City of Portland  
**Bureau of Development Services**  
Land Use Services Division

## **NOTICE OF A TYPE II<sub>x</sub> DECISION ON A PROPOSAL IN YOUR NEIGHBORHOOD**

### **CASE FILE NUMBER: LU 07-145731 LDS**

# ISPAS 4 LOTS SUBDIVISION PROPOSED 4 INDIVIDUAL DWELLINGS

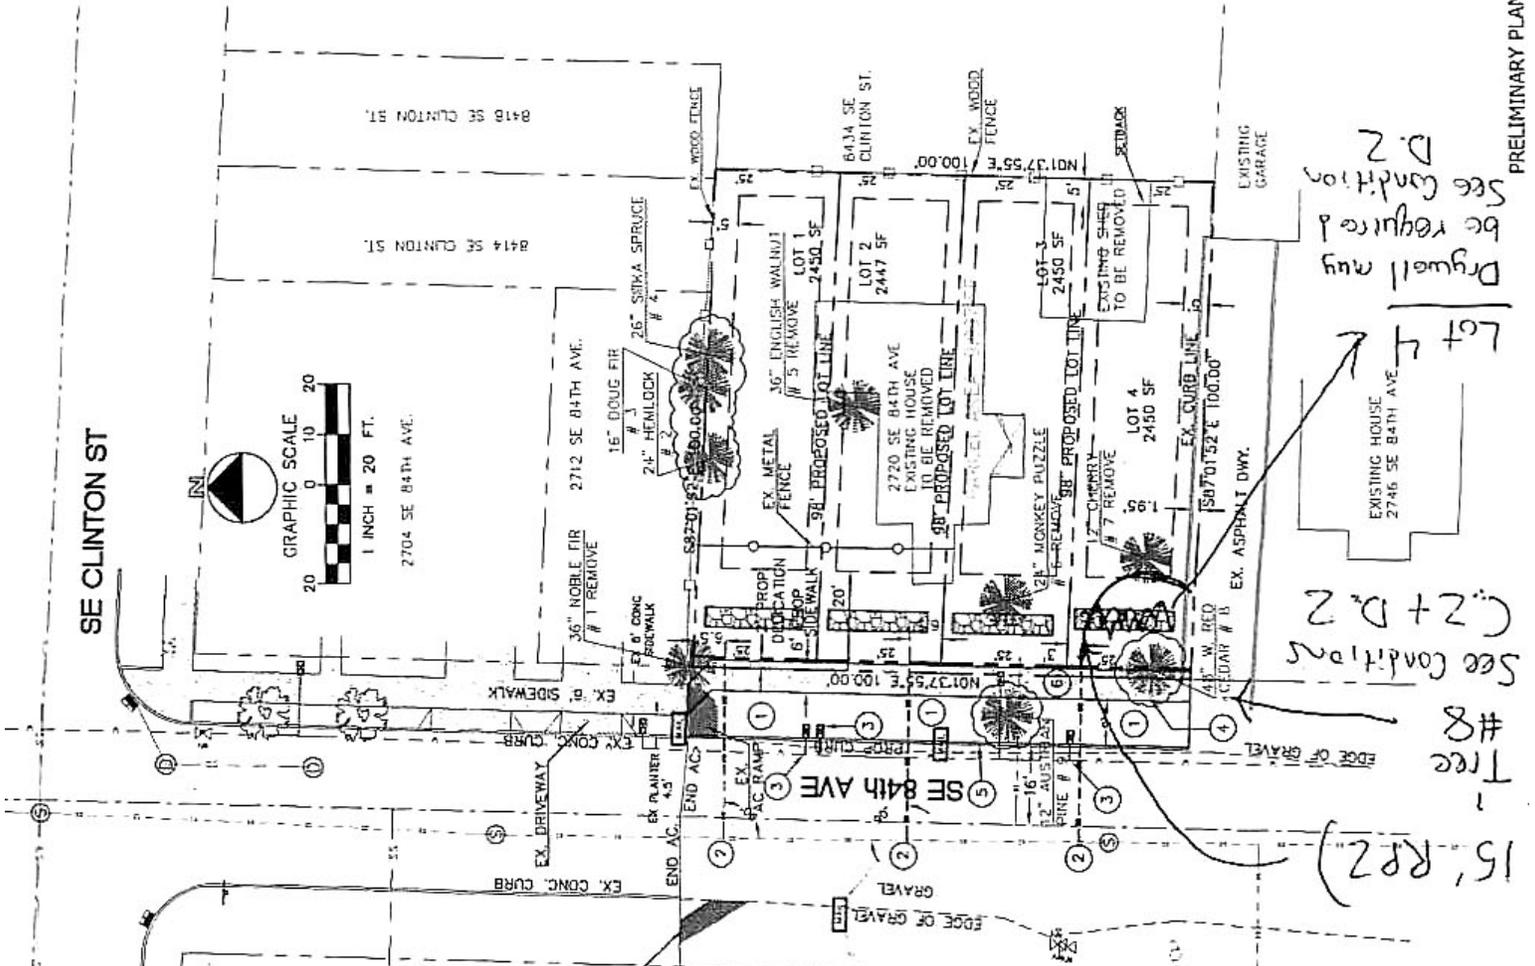
below grade. The current proposal shows a sidewalk within 2 ft. of Tree #8, and a stormwater swale located approximately 7 feet to the west of the tree. Based on optimal conditions, the Urban Forester recommended a curb-tight sidewalk, with no swale in front of tree number 8 on lot 4. Even if PDOT and BES are not able to allow a curb tight sidewalk in front of lot 8 at this location, the tree could still remain viable if proper care techniques are done during the construction of the frontage improvements.

The site plan (exhibit C-1) shows a stormwater infiltration system being placed in the front setback of lot 4. As a condition of approval, the applicant will be required to place its on site stormwater management system as far from tree number 8 as possible on the site. Lastly, as a condition of approval, prior to Planning and Zoning approval of any building permits on lot 4, the applicant will be required to have a letter from an arborist stating that they will be on-site throughout the construction process, including when any excavation work is preformed on lot 4. The arborist should also provide written documentation that specifically states that they will be on site and observe the installation of the driveway and any utilities, or heavy construction materials that need to cross within the 15 ft. radius metal fence the arborist has recommended around tree 8 during construction. Additionally, the arborist shall provide a follow up letter, following completion of all construction work on lot 4, but prior to the final of the building permit for the new unit on lot 4. The follow up letter the arborist provides should give status report on the health of tree number 8 following all construction activities on lot 4.

2. If required per condition C.2 above (see final plat approval letter), the applicant will be required to protect Tree number 8, a 48-inch western red cedar located in the Southwest corner of lot 4 (exhibit C-1). The applicant is required to install a metal fence 15-ft. away from the trunk of tree 8, on lot 4. The applicant should obtain a letter prior to Planning and Zoning approval that documents that the arborist will be on site during any excavation work performed on lot 4, the installation of the driveway and the utilities. Additionally, the following must be shown on the site plan:
